Foundation Defect Discussion

- 1 Soil Test**
Soil Test in IRC, Soil test in Foundation Plans, Soil Test requested and Paid For by Amber Cottman. **Soil Test was not performed as requested by Amber Cottman**
- 2 Expansive Soils**
IRC and IBC requirements Expansive soils, Engineered Fill. **Code Requirements were not followed for the presumed Expansive Soils.**
- 3 Elevation of Foundation**
No elevation survey conducted to determine foundation elevation.
- 4 Crawl Space Floor**
Wrong Elevation, Improper Grading, No Base Course, Lead to flooding of the crawlspace

R408.6 Finished grade.

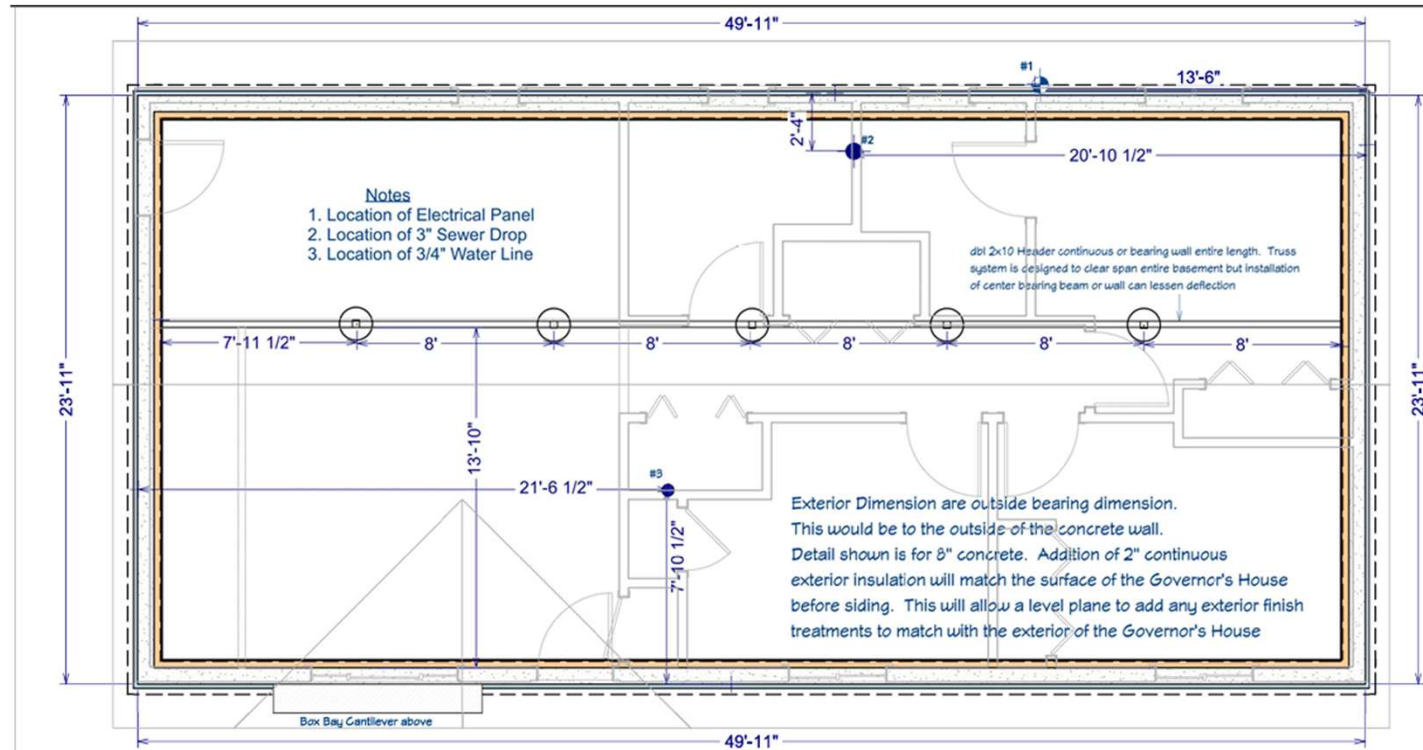
With the high water table in Rapid Valley, precaution should have been taken with the crawlspace floor. The lowest point of the crawlspace floor is below the point that the water table reaches. A soil test and the well would have determined that the crawlspace would flood due to rising water table. An elevation survey measured it to be lower than the water drainage ditch at the front of the home.

Survey – P75

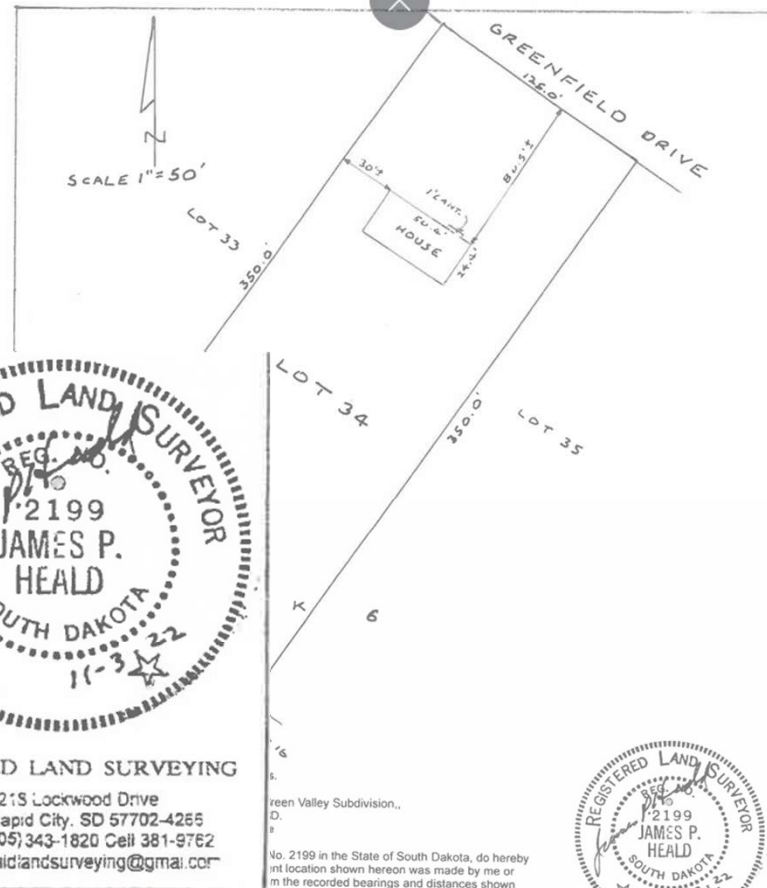
This survey was not an elevation survey. This survey should NOT be used to establish any fence, structure or other improvements.

No elevation survey was conducted to determine elevations for the foundation.

Pictures of Crawlspace Floor

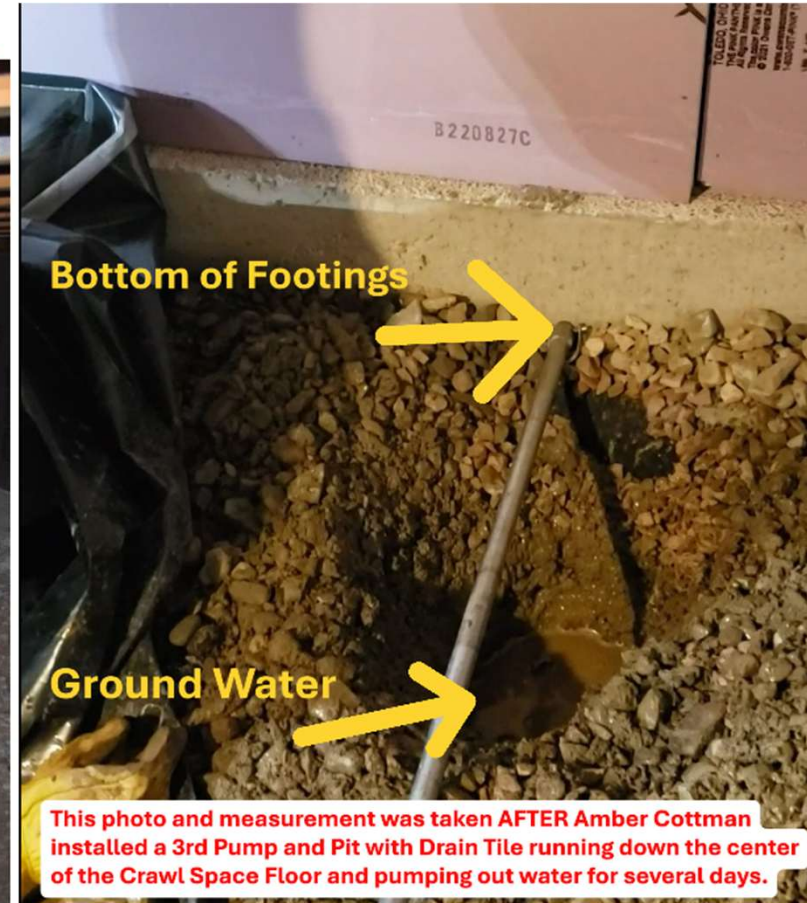
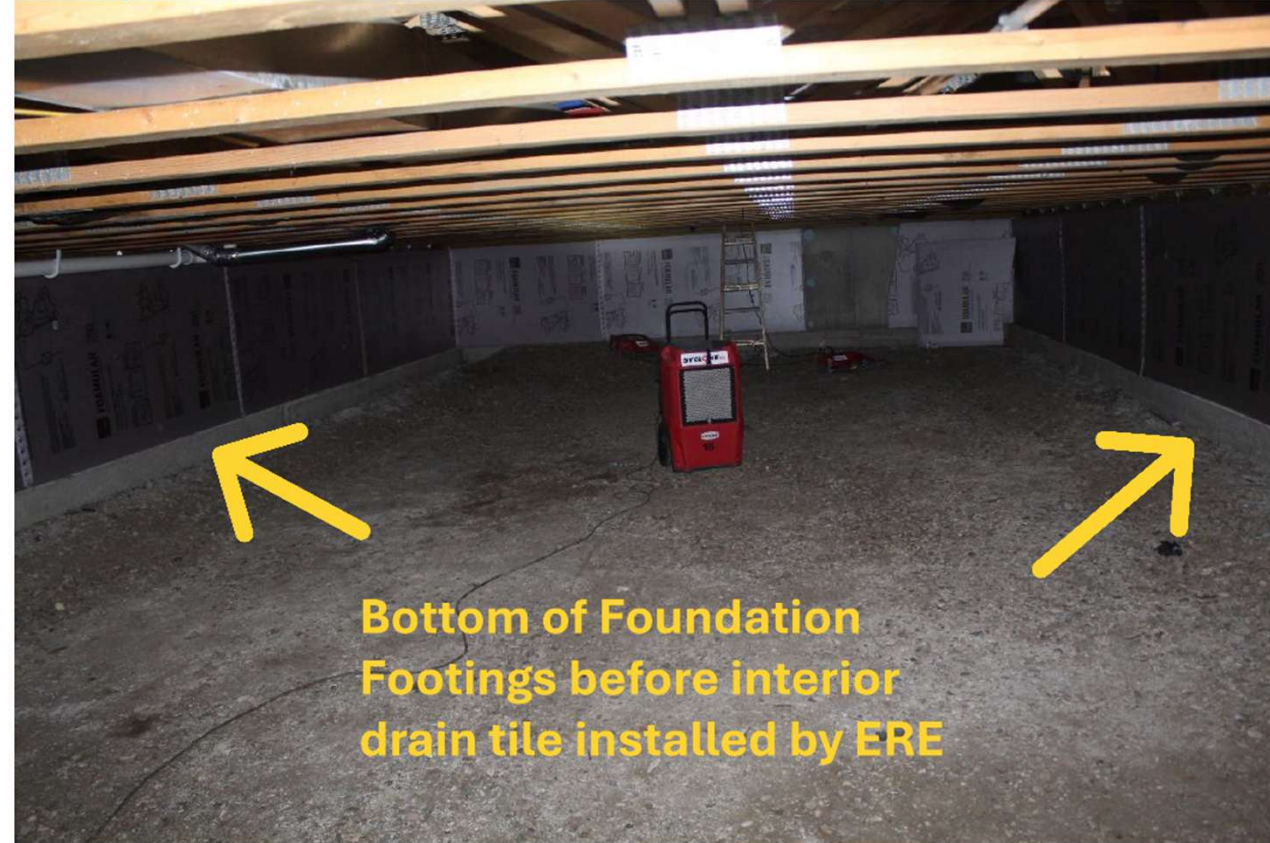
The sump pit should have been installed at the lowest point in the crawl space to be effective and was not.

N1102.2.10 (R402.2.10)Crawl space walls.

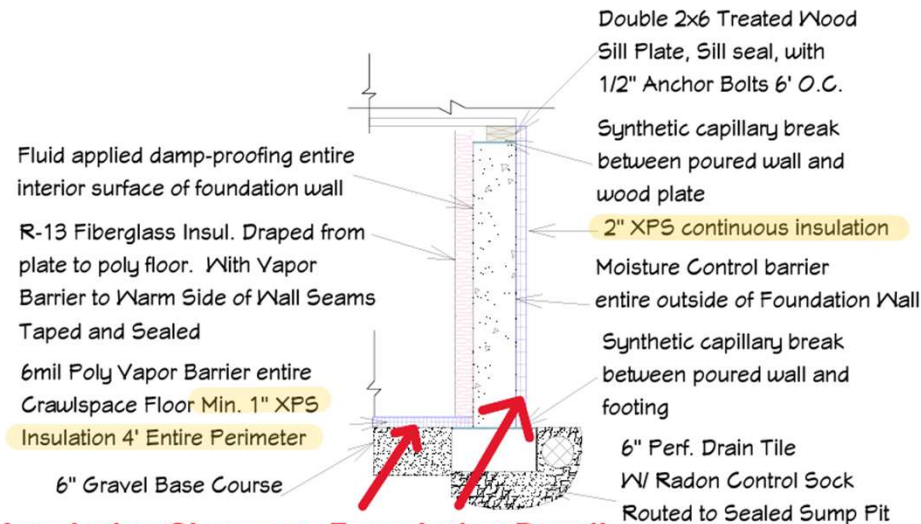
Insulation of the crawl space wall did not meet IRC requirements. No class I vapor retarder installed on exposed earth of concrete floor.

Pictures from Professional Inspection Reports

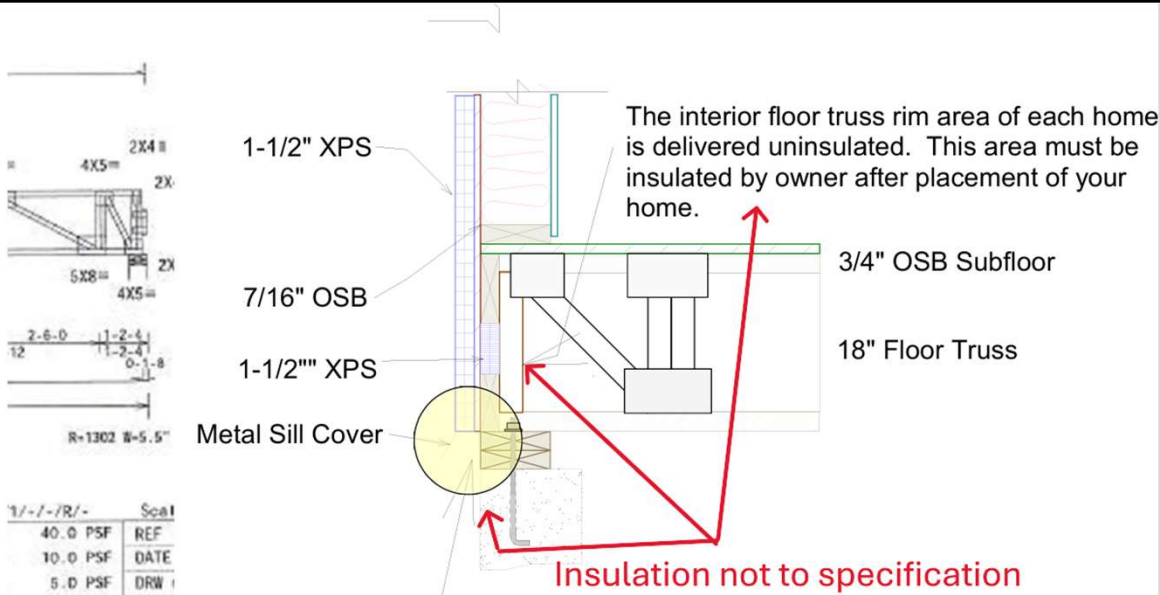
Insulation only reaches the top of the footings. IRC states that it shall extend downwards to the floor of the finished grade and then extend vertically or horizontally and addition 24 inches.

Insulation only goes to the top of the Footing

No insulation on footing. Does not extend 24 Inches

Insulation – Screenshots from IRC and Pics From Plaintiff.

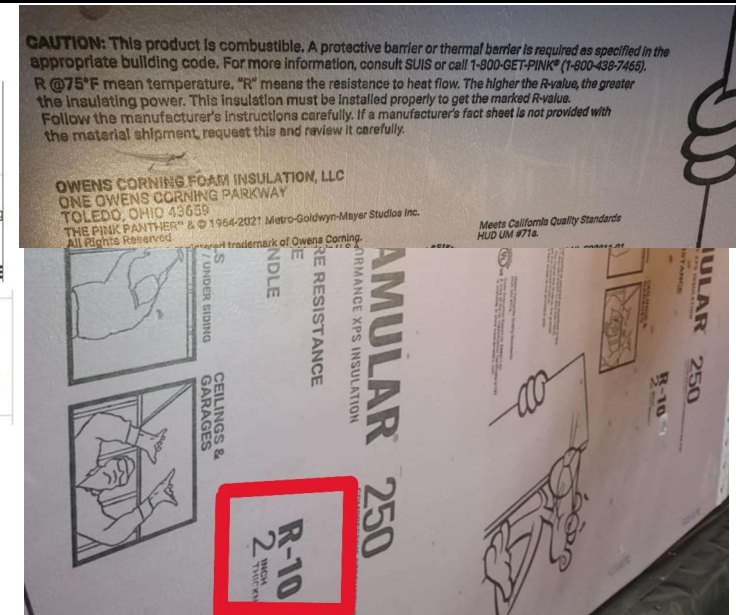
Installed is R-10 and does not meet IRC

These are pictures of the Insulation glued to the stem wall of the foundation.

Pictures from Professional inspection

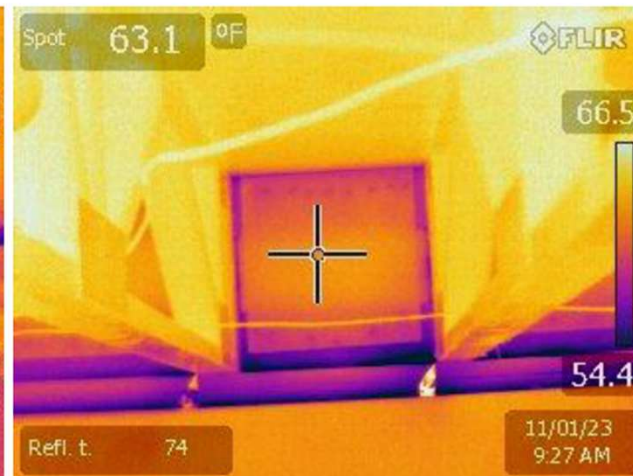
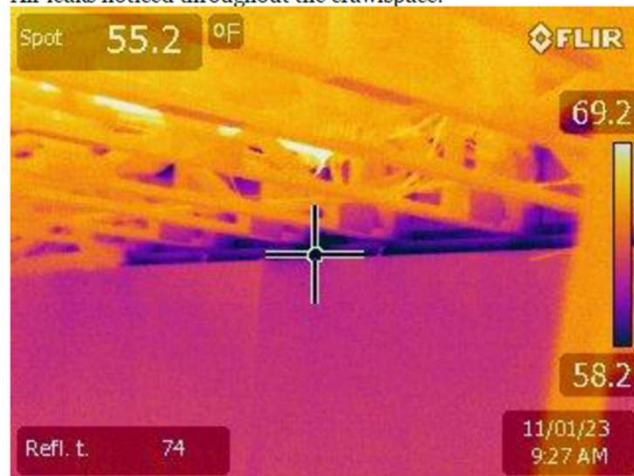
Poorly installed sill plates noticed.

Picture shows no insulation.

Air leaks noticed throughout the crawlspace.

Thermal Imaging from Home Inspection heat loss. The Dark Purple is areas with extreme temperature differences. These are areas that will lose heat or cooling due to lack of proper insulation.

Pictures from BHPI LLC and a Picture with note from Albertson Engineering Inc.

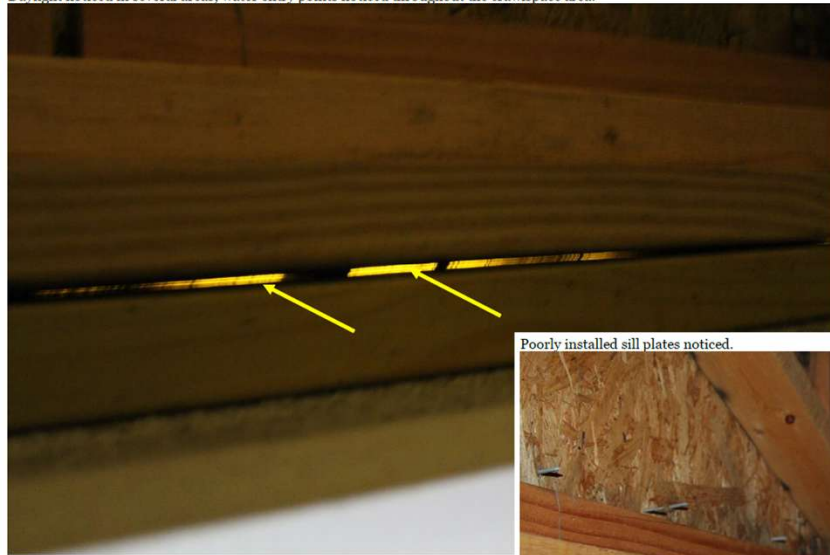
Daylight noticed in several areas; water entry points noticed throughout the crawlspace area.

Double Sill Plate on West Wall

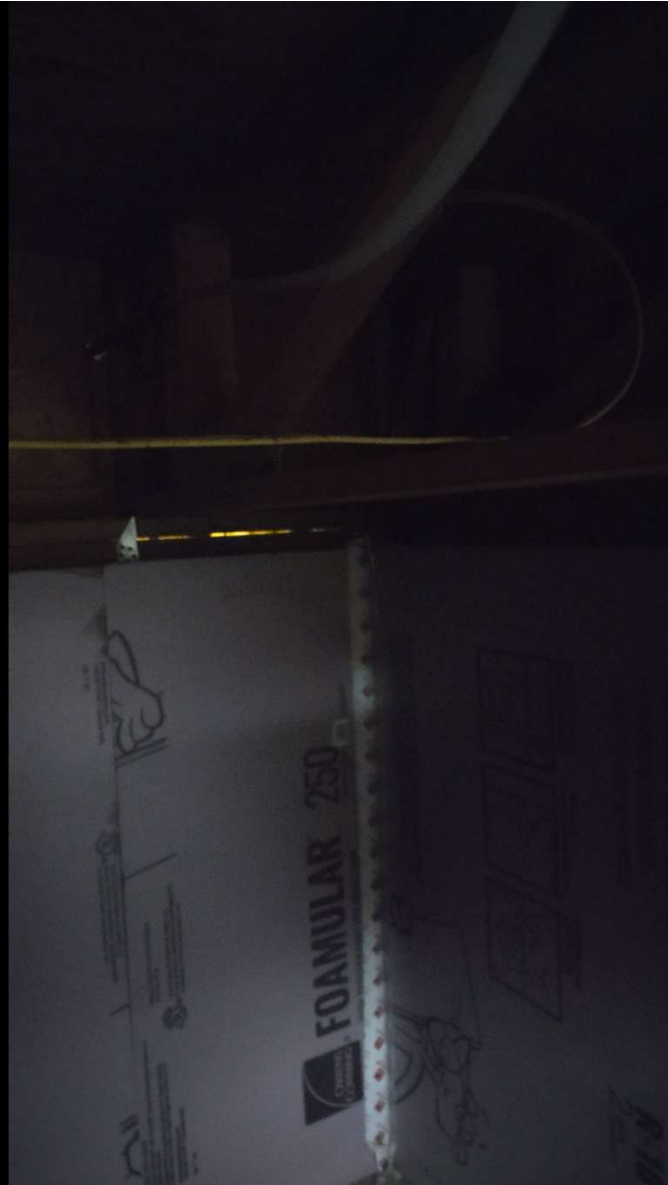
Attempts were made to close the gap in this corner with use of spray-foam insulation. Spray foam has no structural capacity and is not considered a structural repair of the gapping observed.

Poorly installed sill plates noticed.

Pictures from Professional Inspection Report

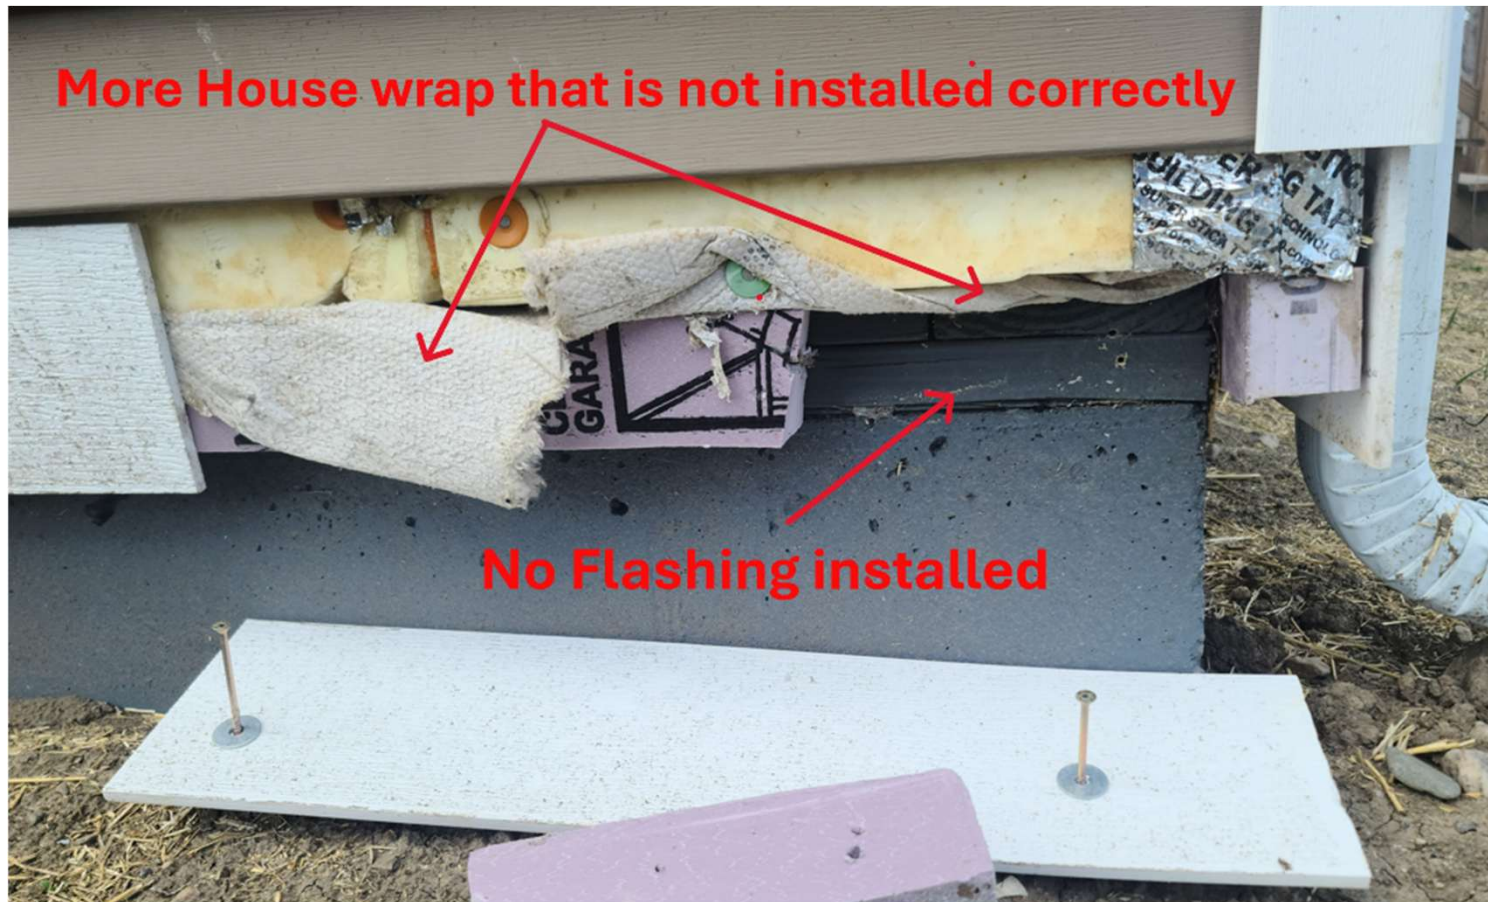
The house wrap was rolled upward, any water getting behind the siding will leak along the whole top of the foundation wall and into the crawlspace and down the foundation wall. (Uncommon Practice)

Unprofessional installation of the house wrap noticed.

House Wrap from SDH is pinned up for transport. It was not correctly installed by contractor. House wrap rolled upward will trap water and direct it into the un-flashed sill plate and into crawlspace.

Pictures from Homeowner

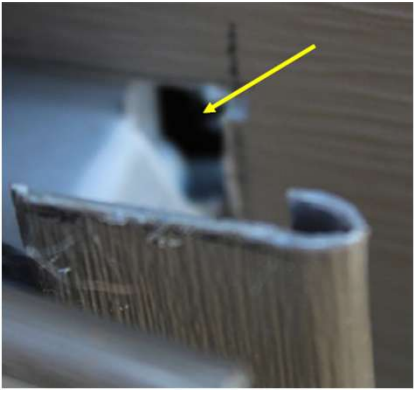
A metal Sill Cover or Flashing was installed around the perimeter of the home.

FORCEFIELD® PREMIUM TAPE

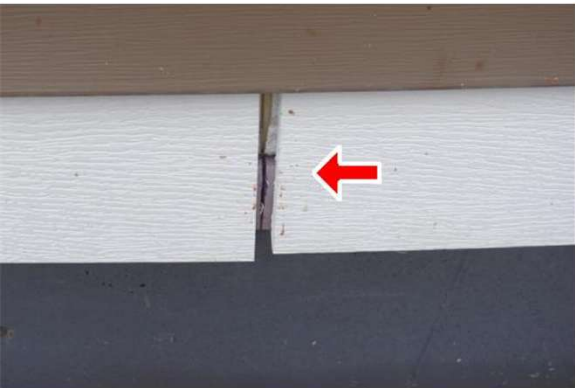
A tape for roof joints and seams was applied to sill plate and concrete connection. The tape quickly released from the concrete created and intrusion point for air, water and insects throughout the entire perimeter of home.

Interior of crawlspace where decks are attached- Pics from Plaintiff

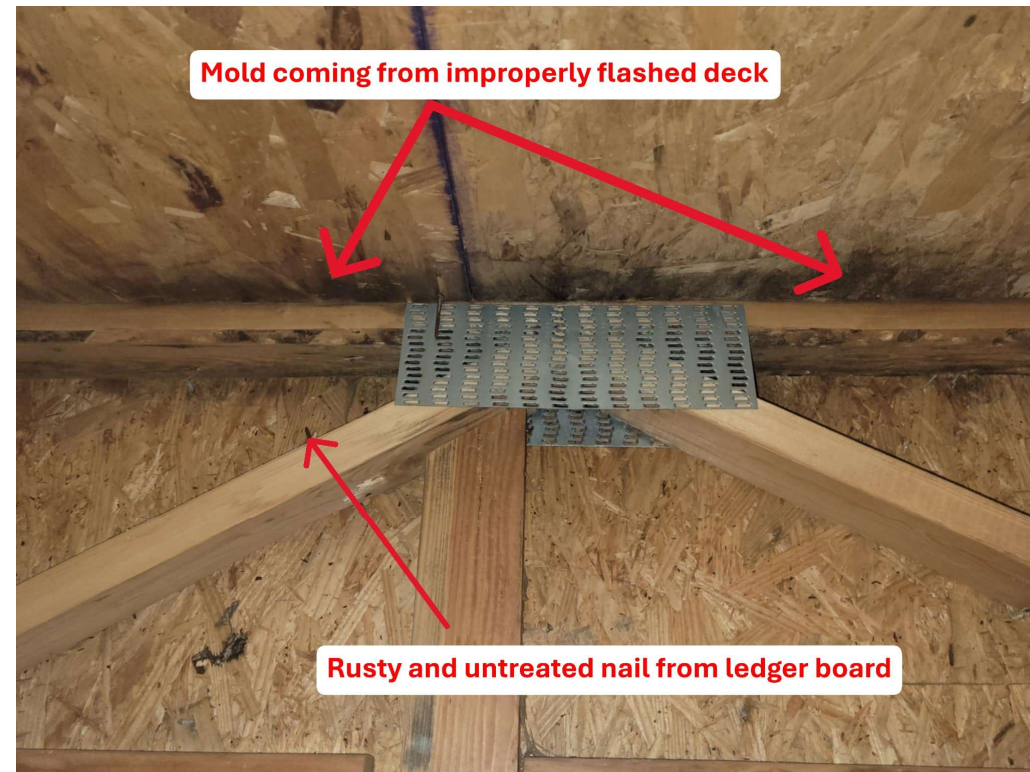
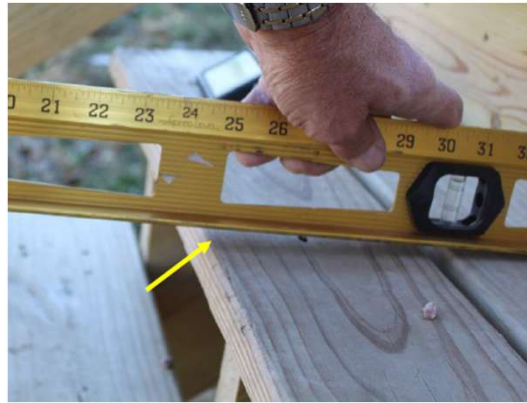
These are picture of where the ledger board of the deck is fastened to the house. You can see a significant amount of water stained and moldy wood. The deck was improperly fastened and without proper flashing.

This led to concerns from the Home Inspector and Amber about the damage to exterior sheathing, insulation and vapor barrier. It became a point of contention when Amber wanted the Decks pulled back and the bottom row of the siding removed to review full scope of the damage.
